Application: 17/03563/PRE

Our ref: 17/03563/PRE
Date: 13th October 2017

Site: 11 Briton Hill Road, South Croydon CR2 0JG

Proposal: Demolishing of existing dwelling and replacing with single block of apartments which is containing 9 flats. Proposal is associated with access, parking spaces for 9 cars, integrated cycle storage and refuse store

TREE PRESERVATION ORDER No.8-1982.

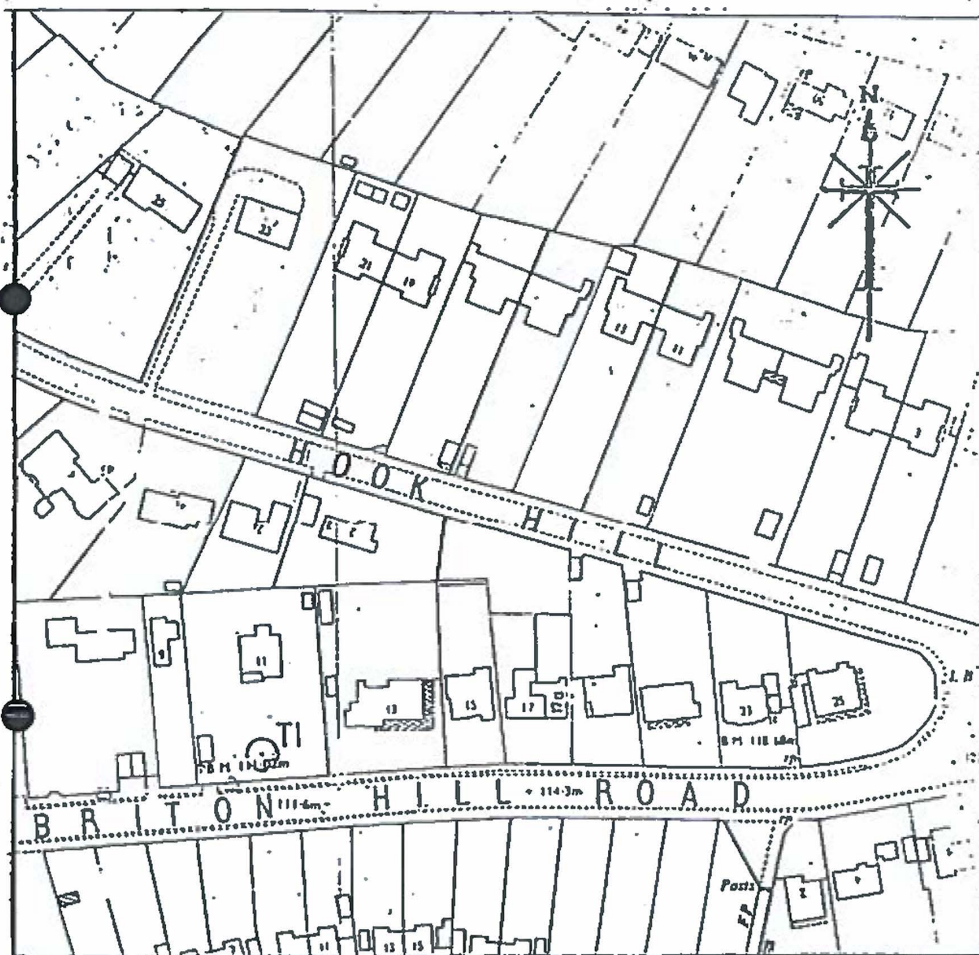
There are no arboriculture objections to the proposed development. However, it appears that there is a TPO (ref; 8, 1982) registered to the property, but I can confirm the tree is not situated in the ground anymore. The records suggest that it was identified as having a spilt trunk in 1990. It appears that no replacement was planted, as such the LPA will arrange for the TPO to be revoked.

TREE PRESERVATION ORDER No.8-1982.

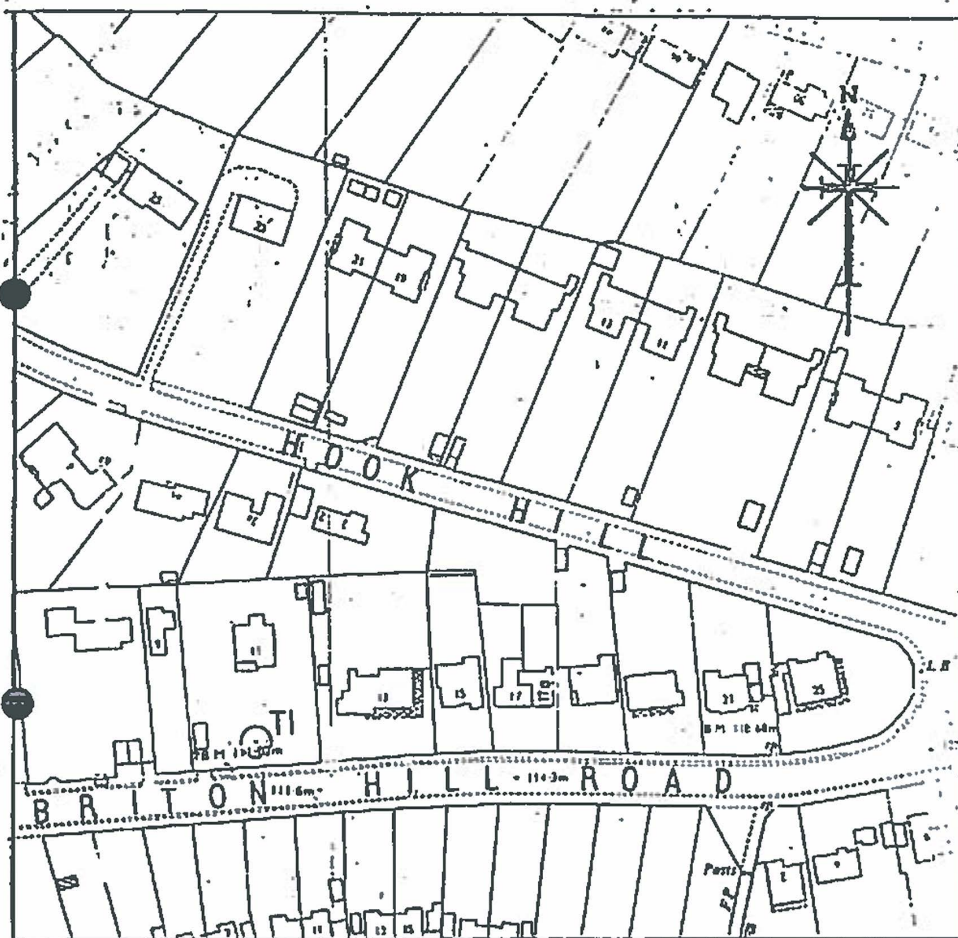
I haven't been to site with this one yet, but it appears to have a Protected Beech at the front TPO no. 8, 1982. But nothing is mentioned in the attached docs on uniform.
